From: Mike Smith <Mike@merithomesinc.com>
Sent: Friday, July 15, 2016 11:51 AM
To: Allison Zike
Subject: RE: SUB16-00483 Aura Check-In

I need some clarification on the area of the access easement through Lot 2. Firstly, I am not seeing that your plans delineate the portion of the easement that runs north from NE 97th across the City tract and Lot 2 to get to the east-west 20' easement. *Can you please get me an exhibit that shows this detail?*

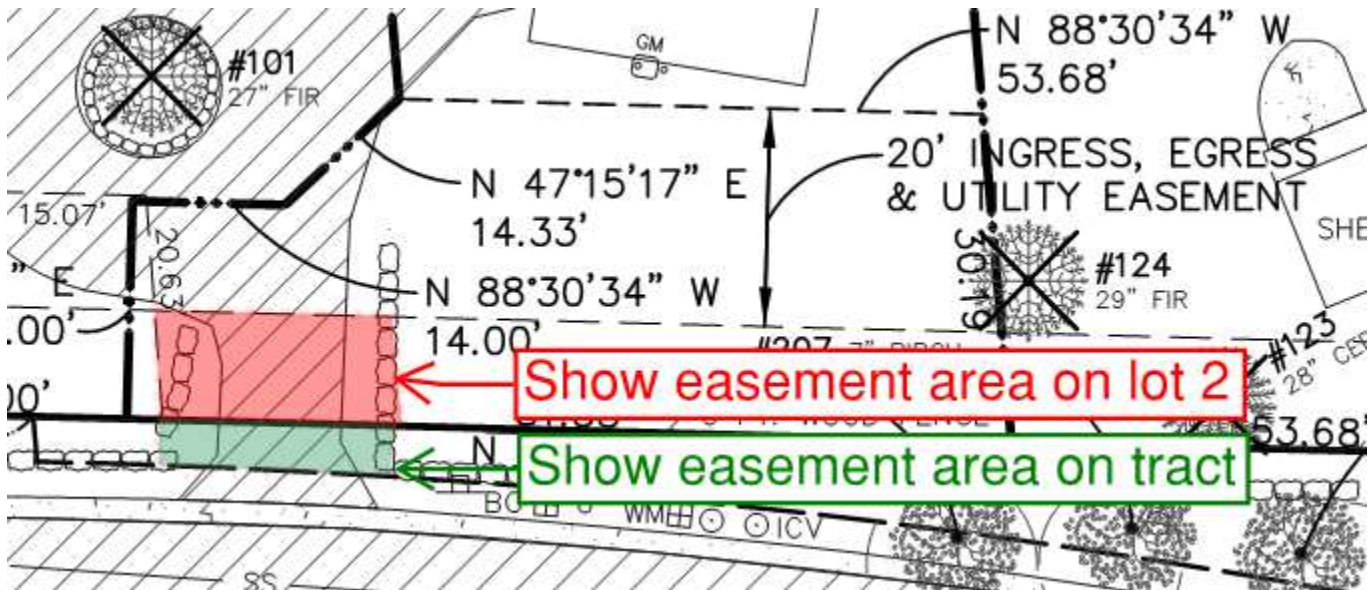
That easement area needs to include the area shown in red below, and I would need an updated net lot area with that taken into consideration.
